Product/Process Change Notice (PCN)

PCN Number: PCN_PeBUTR_20250618 Affected Series: WP-BUTR Affected Part Number: 7460305 ; 7460307 ; 7461084 PCN Date: 2025-03-18 (YYYY-MM-DD) Effective Date: 2025-06-18 (YYYY-MM-DD)	Change Category: ☐ Equipment/Location ☒ General Data ☐ Material ☐ Process ☐ Product Design ☒ Shipping/Packaging ☐ Supplier ☐ Software
Contact: Product Management Phone: +49 (0) 7942 - 945 5001 Fax: +49 (0) 7942 - 945 5179 E-Mail: pcn.eican@we-online.com	Datasheet Change: ☒ Yes ☐ No Attachment: ☐ Yes ☒ No

- Pictures & dimensions

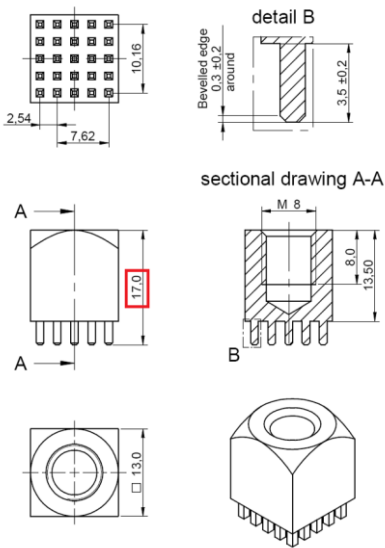
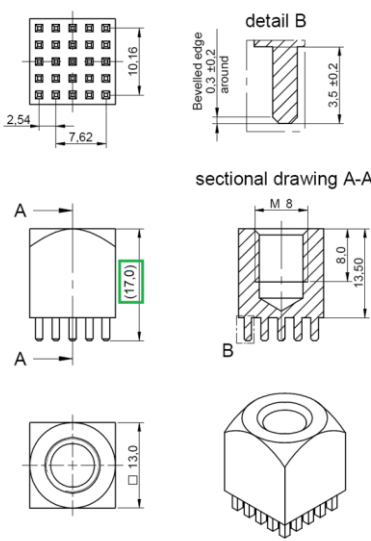
Before Change		After Change	
Carton Case (SPQ)	Shipping Carton (CPQ)	Carton Tray (SPQ)	Shipping Carton (CPQ)

Dimensions (LxWxH):	Dimensions (LxWxH):	Dimensions (LxWxH):	Dimensions (LxWxH):
108.0 x 85.0 x 65.0 mm	300.0 x 200.0 x 115.0 mm	274.0 x 171.0 x 15.0 mm	300.0 x 200.0 x min. 115.0 mm Height varies depending on the component due to two-part carton.
